EXAMINATION of the SEDGEFIELD PLAN

Questions

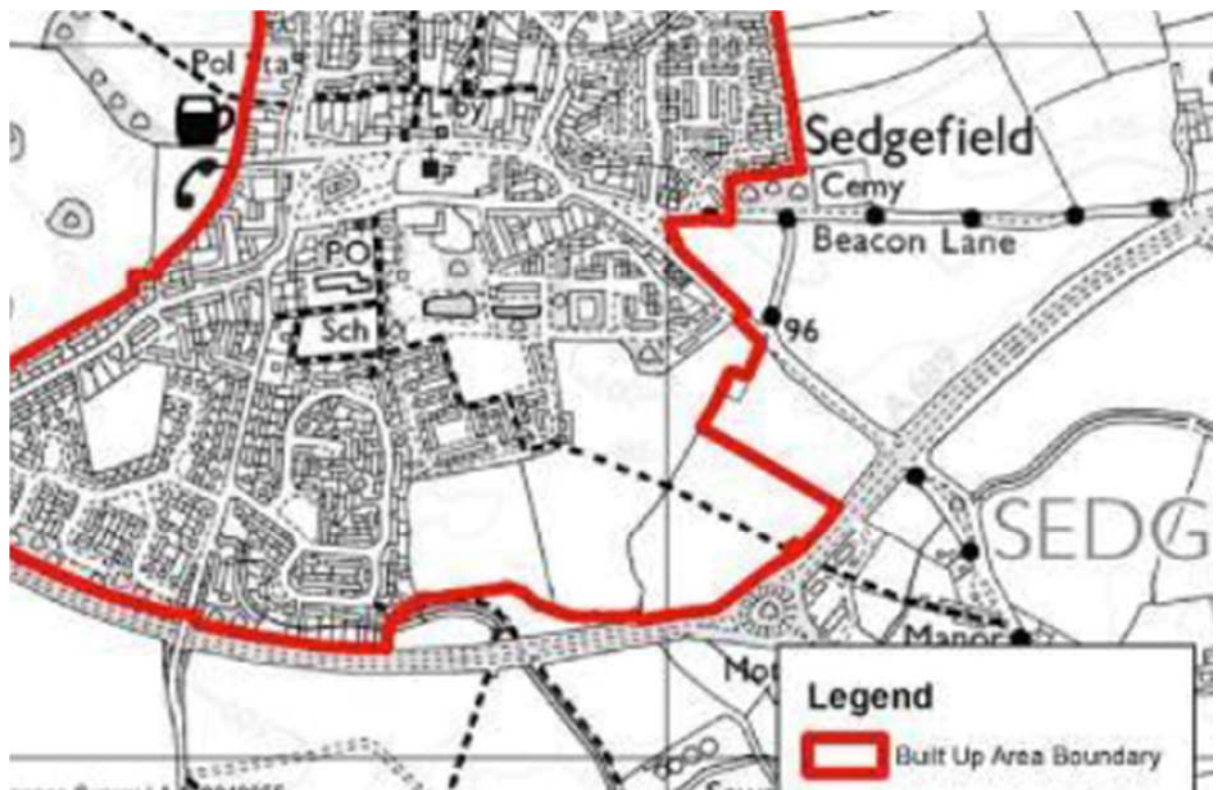
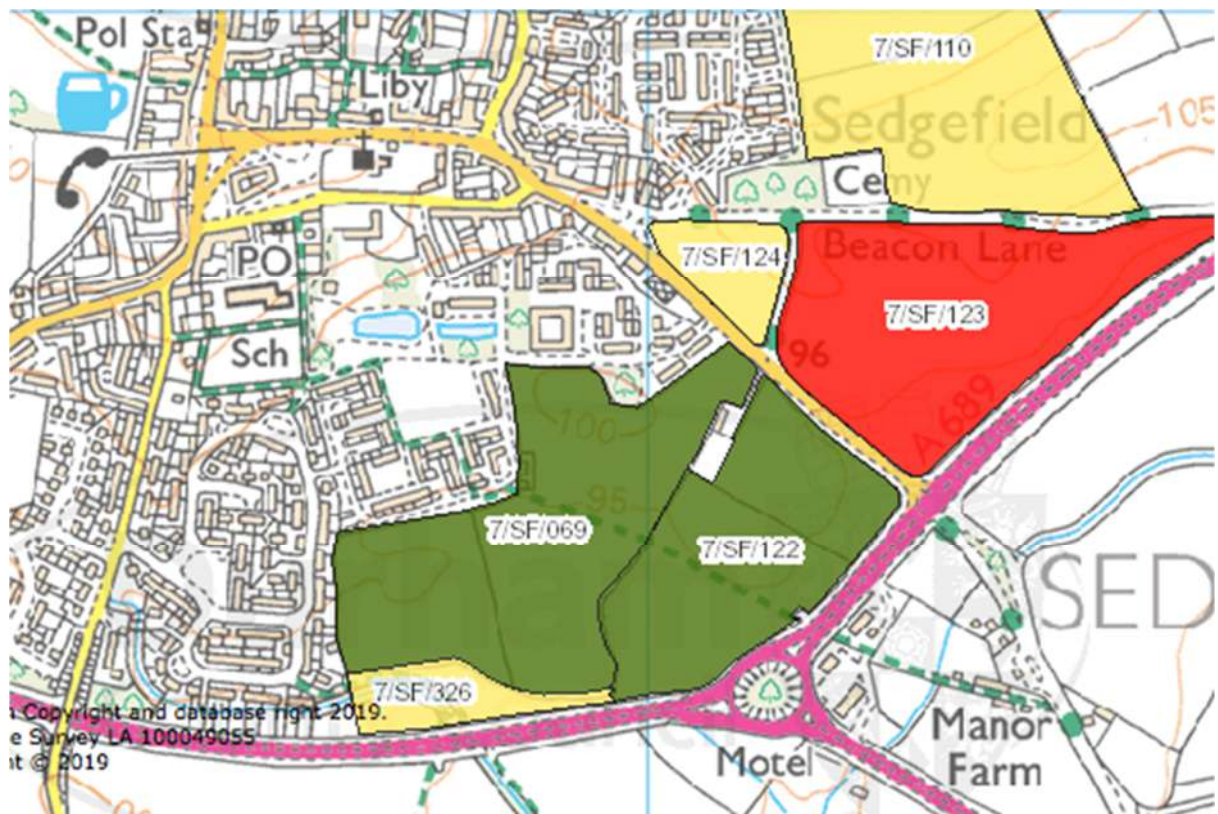
Q2. I note the built-up area boundary is based on planning permission commitments. However the SHLAA 2019 and its associated maps show site 7/SF/122, land at Stockton Road, granted planning permission on appeal, as extending further than that indicated by the proposed built-up area boundary. The Plan built-up area boundary does not extend as far east as that shown on the SHLAA maps. Furthermore, I cannot trace an allowed appeal relating to Stockton Road on the Council's web site search. I can only discover an appeal, which was withdrawn. Please can either the Town Council or the Council clarify the reason there is a difference in these boundaries and that permission has been granted on the land at Stockton Road and if so the extent of the boundary?

I attach screen shots of the relevant map and built-up area boundary shown in the Plan.

- *The proposed built-up area boundary is reflective of existing permissions.*
- *Permission was refused for a hybrid proposal (ref: DM/15/03808/OUT) on the South of Eden Drive site for a total of 300 units (220 in outline and full permission for 80).*

- *This was subsequently allowed at appeal - reference: APP/X1355/W/16/3150609*
- *Reserved matters (ref: DM/17/01322/RM) was approved for 197 on the larger portion of the site (SHLAA ref 7/SF/ 069).*

- *Both schemes have started on site.*
- *SHLAA site 7/SF/122 has not been split up to reflect the permission on part of that site, and therefore covers the paddock to the east which is currently the subject of a separate planning application (pending consideration for 60 units – ref: DM/18/00536/FPA).*

- *The Town Council propose a built-up area boundary which effectively excludes the eastern portion of site 7/SF/122 which is currently under consideration, as the Town Council consider that sufficient new housing is already in place.*

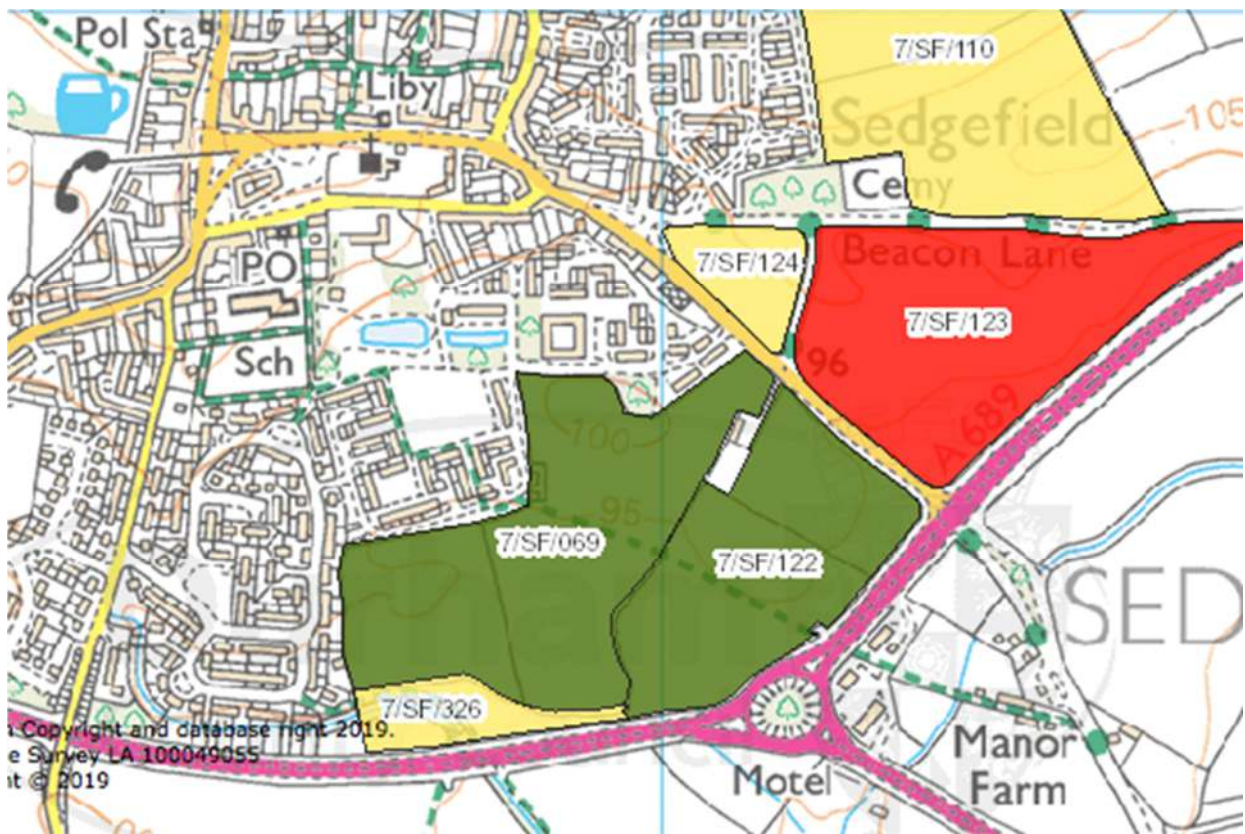
Q3. The Policy justification on page 23 refers to a field “at the entrance to the community” where there is a need to protect the ridge and furrow archaeology and views of the church. Where is this land? If so, is it the land that I refer to above that has been excluded from the built-up area boundary?

The field in question is referred to localised as the ‘three-cornered field’ and is identified as the yellow triangle labelled 7/SF/124 below, just outside the built-up area boundary (see map below).
